IDAP REPORT

Property:	14 Wentworth Street GREENACRE DA 2020/154
Proposal:	Demolition of the existing dwelling and construction of a dual occupancy development with basement level parking.
Applicant:	ZTA Group
Owner:	Zar Development Pty Ltd
Date of lodgement:	9 September 2020
Notification period:	18 September 2020 to 3 October 2020
Submissions received:	Nil
Assessment officer:	N. Doughty
Estimated cost of works:	\$940,653.00
Zoning:	R2-Low Density Residential Additional Permitted Uses 'Item 1' – SLEP 2012
Heritage:	No
Flood affected:	Yes
Is a Clause 4.6 Variation Proposed:	No
RECOMMENDATION OF OFFICER:	APPROVAL

Figure 3: Proposed site plan

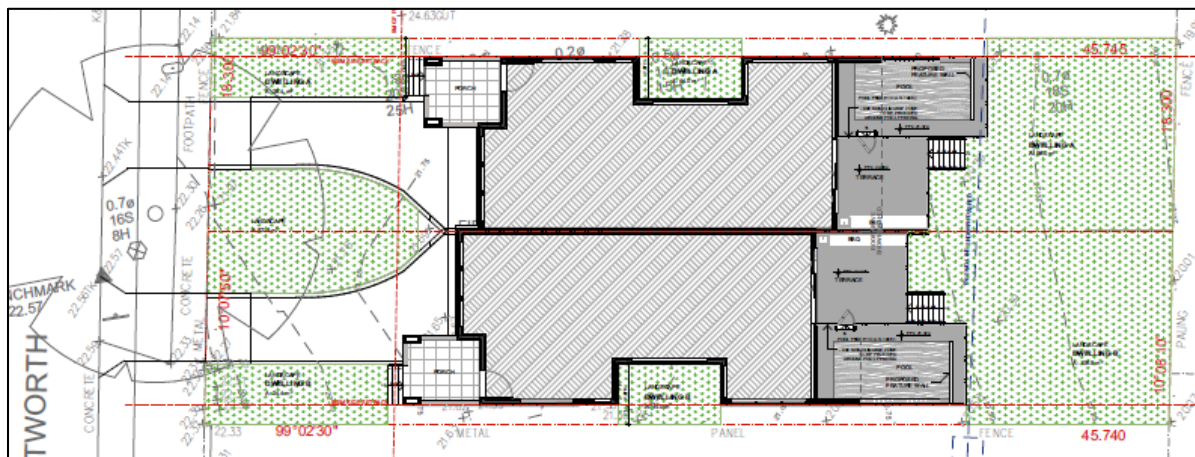
- *"The driveway layback to Dwelling A shall be modified to provide 3m setback from the street tree;*
- *All trees are to be planted from 100 litre containers and shall not be planted closer than 2.5m from a dwelling or property boundary."*

"It is noted that the amended plans propose two separate driveways to retain an existing tree. This proposal would require vehicles to either enter or exit the site in reverse movement. Considering the site constraints, the minimal traffic movements associated with the development and low traffic flow along Wentworth Street, this arrangement is considered acceptable."

Driveway width	The vehicular access driveway width for both dwellings must be no more than 3m at the front boundary line. Any front fence or gate opening adjustments required as a result of this reduction must be illustrated on the plans lodged with the application for the Construction Certificate.
Vehicular crossover width	The vehicular crossover and layback of Dwelling A be must located a minimum of 3m from the trunk of the street tree. Any driveway, front fence or gate opening adjustments required as a result of this condition must be illustrated on the plans lodged with the application for the Construction Certificate.
Landscape Plan	The six (6) canopy trees shown on the approved Landscape Plan are to be planted from 100 litre containers and be located no closer than 2.5m from a dwelling or property boundary.
